# UNITED STATES PATENT AND TRADEMARK OFFICE

APPLICATION NO.	FILING DATE	FIRST NAMED INVENTOR	ATTORNEY DOCKET NO.	CONFIRMATION NO.
10/738,355	12/16/2003	Rodney J. Clements	10617	7570

## Office Action Summary

## **DETAILED ACTION**

【図 1】

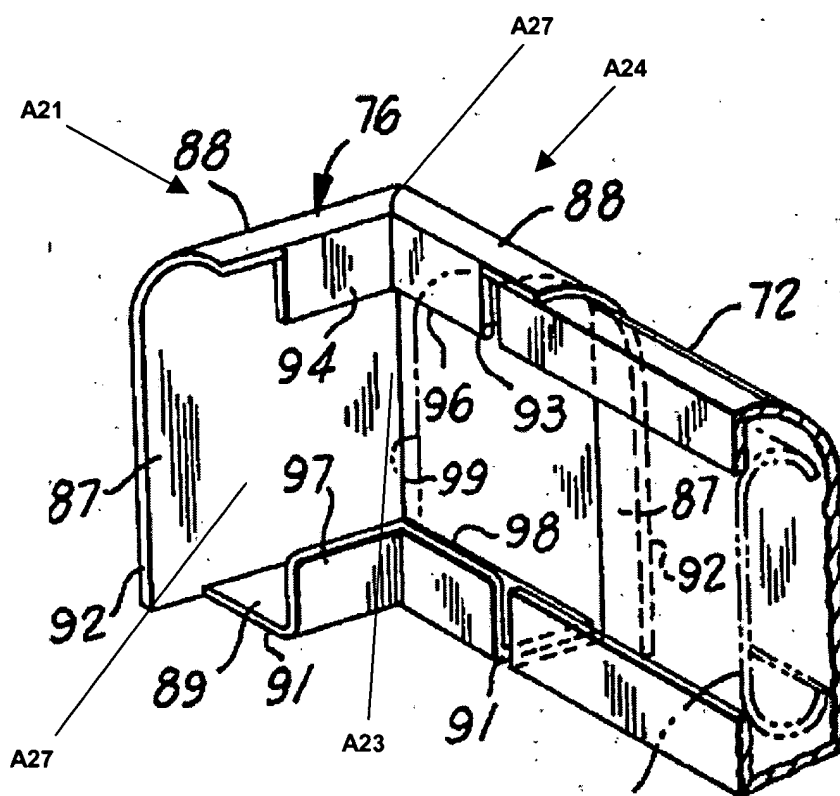
Regarding claim 12, the Japanese patent discloses, in Figure 1, a receptacle comprising a first receiver **A21**, a second receiver **A24**, and a juncture **A27**. The first receiver **A21** and the second receiver **A24** each have an open outer end **A22** and an inner end **A23**. The outer end **A22** of the first receiver **A21** includes an upper lip **2**, a lower trough **3**, and an inner wall **A3** therebetween. The outer end **A22** of the second receiver **A24** includes an upper lip **2**, a lower trough **3**, and an inner wall **A3** therebetween. The juncture **A27** is between the inner end **A23** of the first receiver **A21** and the inner end **A23** of the second receiver **A24**. The first receiver **A21** and the second receiver **A24** each have an internal cavity **A28** respectively extending from the outer end **A22** to the inner end **A23**. Applicant is reminded that the internal cavity **A28** is sized and configured snugly to accommodate and cover an end portion of a piece of molding or trim inserted therein.

Regarding claim 13, the juncture **A27** comprises an outside corner. The first receiver **A21** and the second receiver **A24** have axes maintained at 90 degrees, 120 degrees, or 135 degrees with respect to each other.

Regarding claim 14, the juncture **A27** comprising an inside corner. The first receiver **A21** and the second receiver **A24** each have an axis maintained at 90 degrees, 120 degrees, or 135 degrees with respect to each other (Fig. 4).

Regarding claims 16 and 22, the upper lip **2** includes an upwardly inclined section **A** extending to the inner wall **A3** and a vertical section **2a** extending downwardly along the inner wall **A3**. The lower trough **3** includes a horizontal section **3a** extending to the inner wall **A3** and a vertical section **3b** extending upwardly along the inner wall **A3**.

Regarding claims 17 and 23, the retaining means **1** comprises at least one rib extending along the inner wall **A3** of the first receiver **A21** and the second receiver **A24**.

Regarding claim 20, the Japanese patent discloses, in Figure 1, a receptacle comprising a first receiver **A21**, and a second receiver **A24**. The first receiver **A21** has an open outer end **A22** provided with an upper lip **2**, a lower trough **3**, and an inner wall **A3** therebetween. The second receiver **A24** has an open outer end **A22** provided with an upper lip **2**, a lower trough **3**, and an inner wall **A3** therebetween. The juncture **A27** is between the inner end **A23** of the first receiver **A21** and the inner end **A23** of the second receiver **A24**. The first receiver **A21** and the second receiver **A24** each have an internal cavity **A28** respectively extending from the outer end **A22** to the inner end **A23**. Applicant is reminded that the internal cavity **A28** is sized and configured snugly to accommodate and cover an end portion of a piece of molding or trim inserted therein.

Regarding claim 24, the Japanese patent discloses, in Figure 1, a receptacle comprising a first receiver **A21**, a second receiver **A24**, and a juncture **A27**. The first receiver **A21** and the second receiver **A24** each have an open outer end **A22** and an inner end **A23**. The outer end **A22** of the first receiver **A21** includes an upper lip **2**, a

Woods, 3,074,521

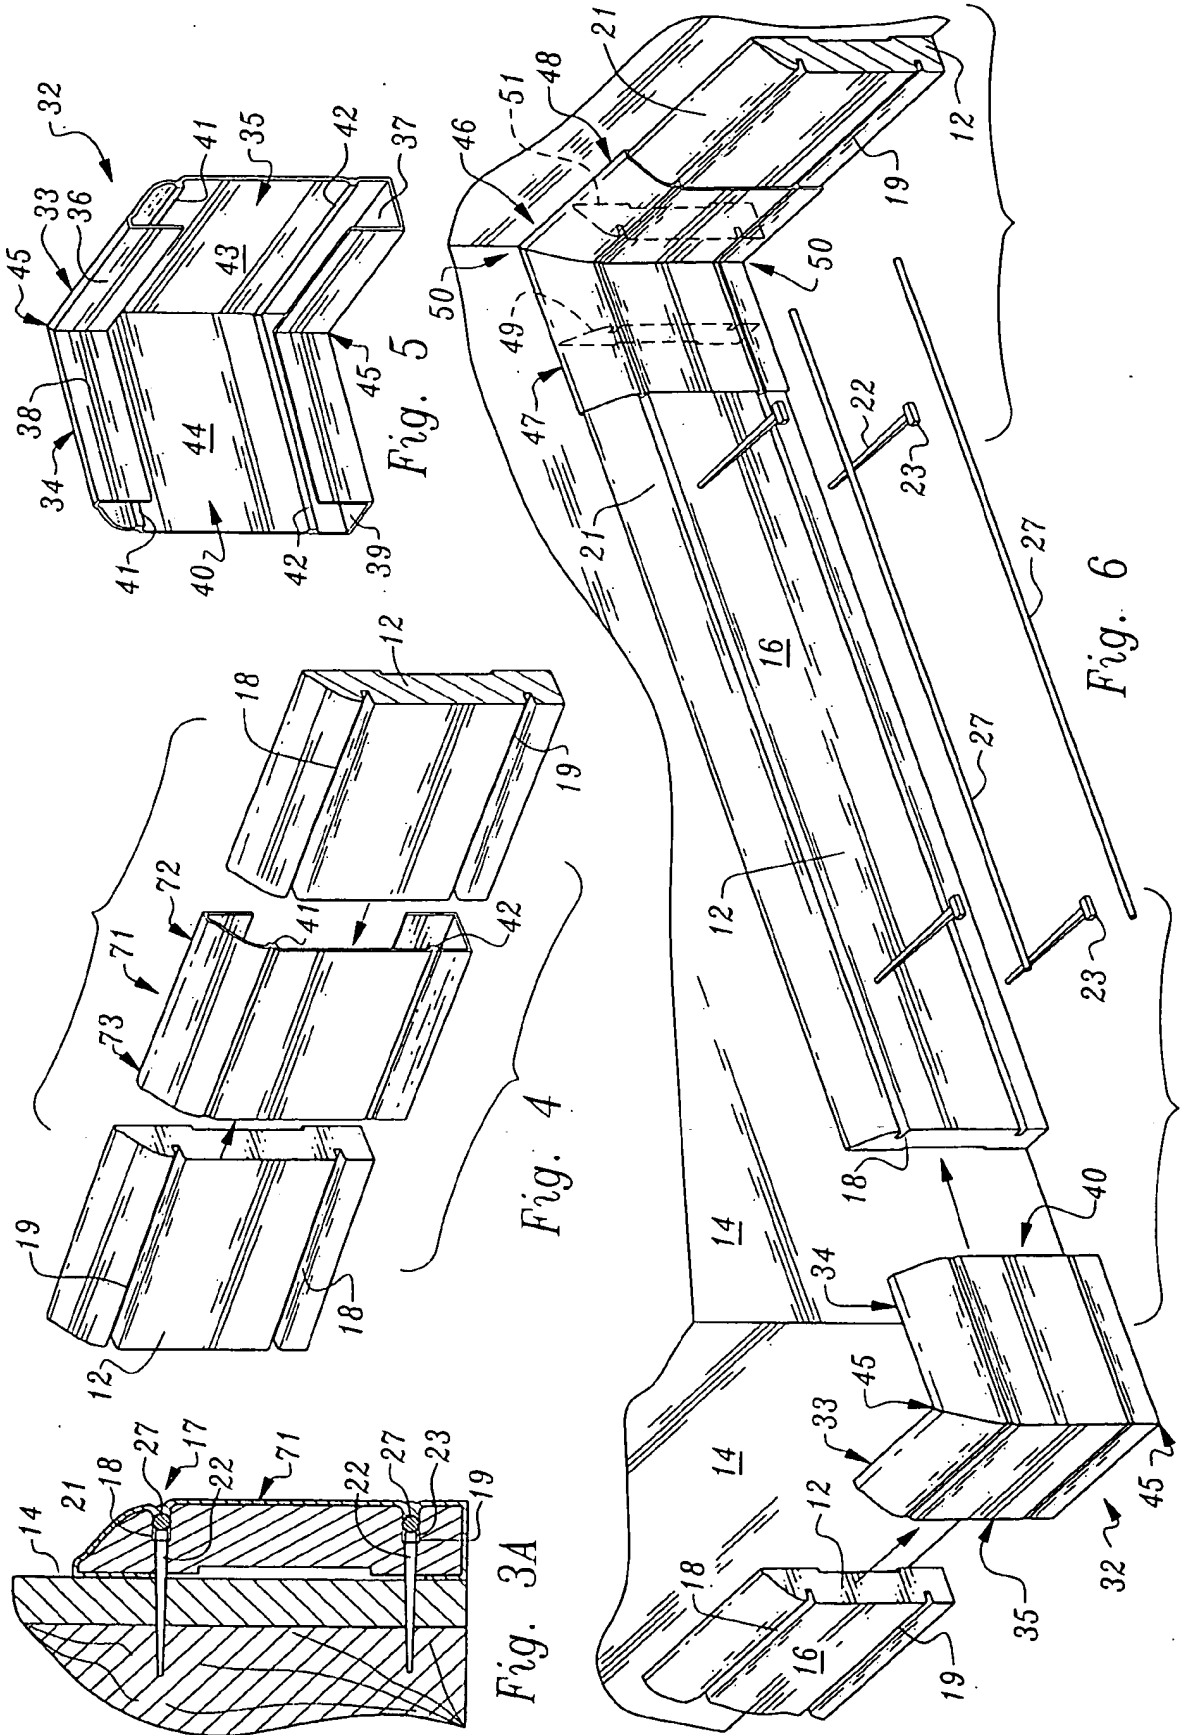
Regarding claim 12, Woods discloses, in Figure 10, a receptacle comprising a first receiver **A21**, a second receiver **A24**, and a juncture **A27**. The first receiver **A21** and the second receiver **A24** each have an open outer end **A22** and an inner end **A23**. The outer end **A22** of the first receiver **A21** includes an upper lip **93,95**, a lower trough **85,87**, and an inner wall **79,81** therebetween. The outer end **A22** of the second receiver **A24** includes an upper lip **93,95**, a lower trough **85,87**, and a inner wall **79,81**

Regarding claim 13, the juncture **A27** comprises an outside corner. The first receiver **A21** and the second receiver **A24** have axes maintained at 90 degrees, 120 degrees, or 135 degrees with respect to each other.

Regarding claims 15 and 21, the first receiver **A21** and the second receiver **A24** include retaining means **89,91**. Applicant is reminded that the retaining means **89,91** can secure molding or trim to the coupler without the use of fasteners or adhesives.

Regarding claim 18, the first receiver **A21** and the second receiver **A24** define respective planes which are oblique with respect to each other. Applicants should note that "substantially at a 270 degrees" as defined in column 5, line 38 allows for variation

Regarding claim 20, Woods discloses, in Figure 10, a receptacle comprising a first receiver **A21**, and a second receiver **A24**. The first receiver **A21** has an open outer end **A22** provided with an upper lip **93,95**, a lower trough **85,87**, and an inner wall **79,81** therebetween. The second receiver **A24** has an open outer end **A22** provided with an upper lip **93,95**, a lower trough **85,87**, and an inner wall **79,81** therebetween. The juncture **A27** is between the inner end **A23** of the first receiver **A21** and the inner end **A23** of the second receiver **A24**. The first receiver **A21** and the second receiver **A24** each have an internal cavity **A28** respectively extending from the outer end **A22** to the inner end **A23**. Applicant is reminded that the internal cavity **A28** is sized and configured snugly to accommodate and cover an end portion of a piece of molding or trim inserted therein.

Regarding claim 24, Woods discloses, in Figure 10, a receptacle comprising a first receiver **A21**, a second receiver **A24**, and a juncture **A27**. The first receiver **A21** and the second receiver **A24** each have an open outer end **A22** and an inner end **A23**. The outer end **A22** of the first receiver **A21** includes an upper lip **93,95**, a lower trough **85,87**, and an inner wall **79,81** therebetween. The outer end **A22** of the second receiver **A24** includes an upper lip **93,95**, a lower trough **85,87**, and an inner wall **79,81** therebetween. The juncture **A27** is between the inner end **A23** of the first receiver **A21** and the inner end **A23** of the second receiver **A24**. The first receiver **A21** and the second receiver **A24** each have an internal cavity **A28** respectively extending from the outer end **A22** to the inner end **A23**. Applicants are reminded that the internal cavity **A28** is sized and configured snugly to accommodate and cover an end portion of a piece of molding or trim inserted therein.

*Fig. 9*

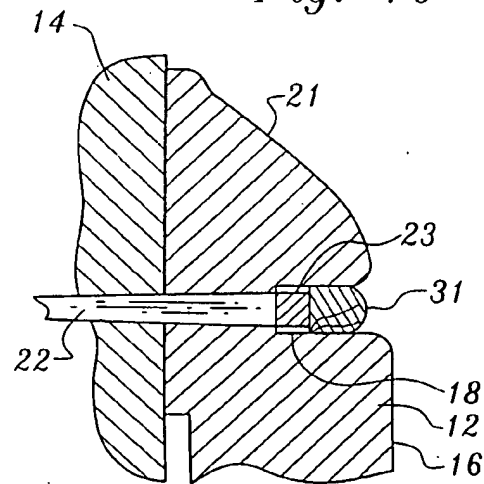
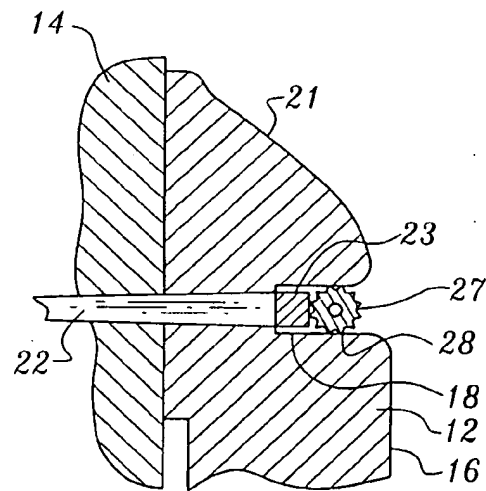
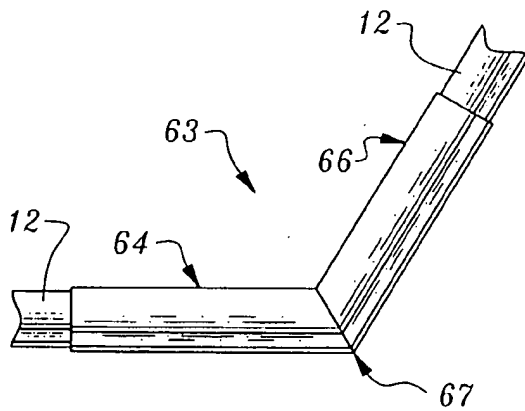
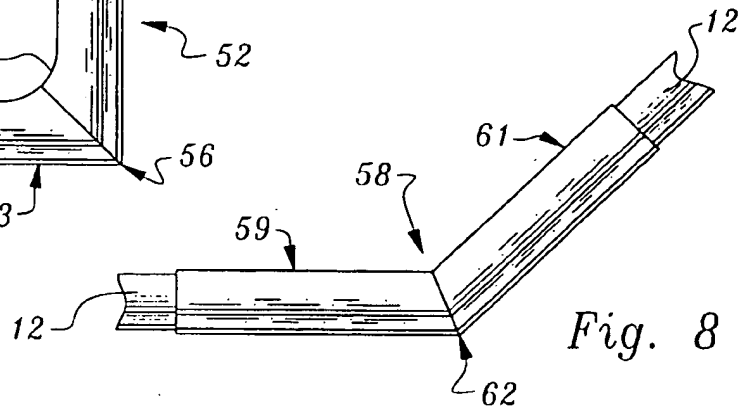
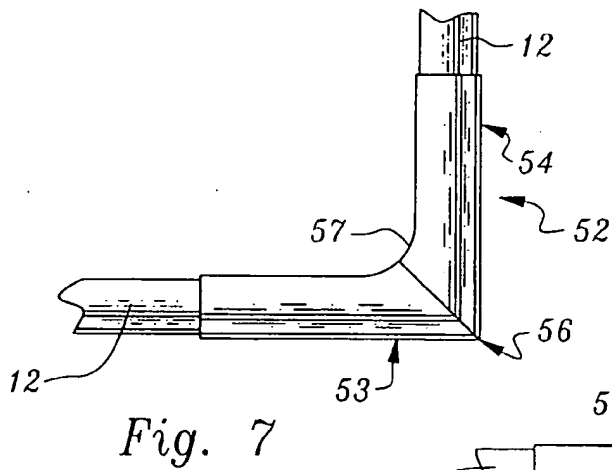
Regarding claim 12, Gooding discloses, in Figure 9, a receptacle comprising a first receiver **A21**, a second receiver **A24**, and a juncture **A27**. The first receiver **A21** and the second receiver **A24** each have an open outer end **91** and an inner end **A23**. The outer end **91** of the first receiver **A21** includes an upper lip **88,94**, a lower trough **89,91**, and an inner wall **87** therebetween. The outer end **91** of the second receiver **A24** includes an upper lip **88,94**, a lower trough **89,91**, and an inner wall **87** therebetween. The juncture **A27** is between the inner end **A23** of the first receiver **A21** and the inner end **A23** of the second receiver **A24**. The first receiver **A21** and the second receiver **A24** each have an internal cavity **A28** respectively extending from the outer end **91** to the inner end **A23**. Applicant is reminded that the internal cavity **A28** is sized and configured snugly to accommodate and cover an end portion of a piece of molding or trim inserted therein.

Regarding claims 16 and 22, the upper lip **88,94** includes an upwardly inclined section **88** extending to the inner wall **87** and a vertical section **94** extending

downwardly along the inner wall **87**. The lower trough **89,91** includes a horizontal section **89** extending to the inner wall **87** and a vertical section **97** extending upwardly along the inner wall **87**.

Regarding claim 20, Gooding discloses, in Figure 9, a receptacle comprising a first receiver **A21**, and a second receiver **A24**. The first receiver **A21** has an open outer end **91** provided with an upper lip **88,94**, a lower trough **89,91**, and an inner wall **87** therebetween. The second receiver **A24** has an open outer end **91** provided with an upper lip **88,94**, a lower trough **89,91**, and an inner wall **87** therebetween. The juncture **A27** is between the inner end **A23** of the first receiver **A21** and the inner end **A23** of the second receiver **A24**. The first receiver **A21** and the second receiver **A24** each have an internal cavity **A28** respectively extending from the outer end **91** to the inner end **A23**. Applicant is reminded that the internal cavity **A28** is sized and configured snugly to accommodate and cover an end portion of a piece of molding or trim inserted therein.
